<b>Service Note</b>		
Products	Description:	Service note no.
<b>Play Electric</b>	<b>Product freezes</b>	<b>SNo-T210</b>

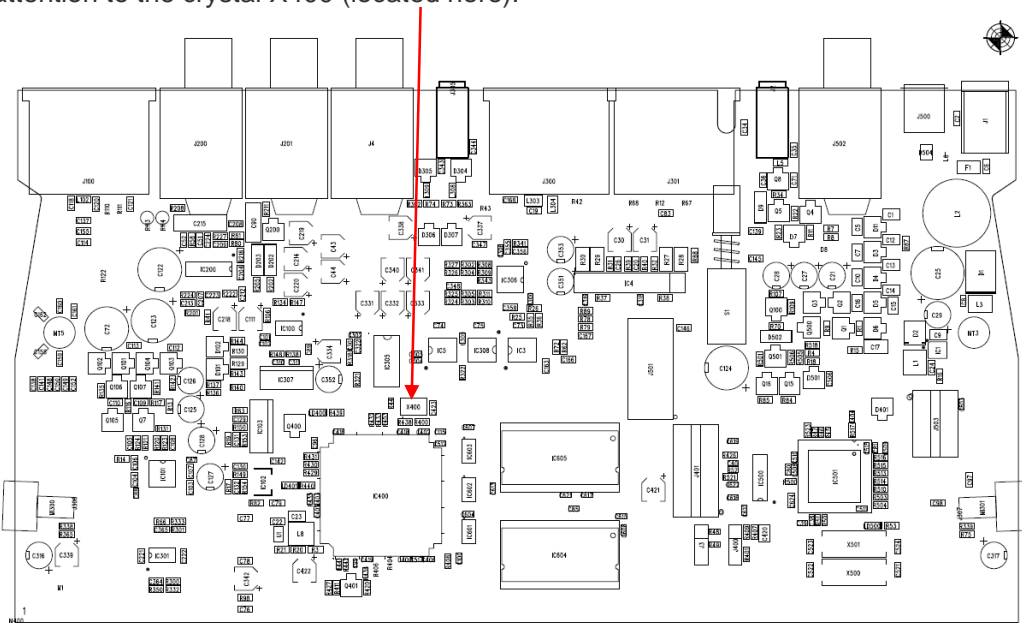
Examinations have shown that some crystals are unstable and sometimes stop oscillation.

When a Play Electric product is in for service with these symptoms, please pay attention to the crystal X400 (located here).

A crystal from Abracon should be used for replacement. For a Music Group part number, please refer to the spare part list
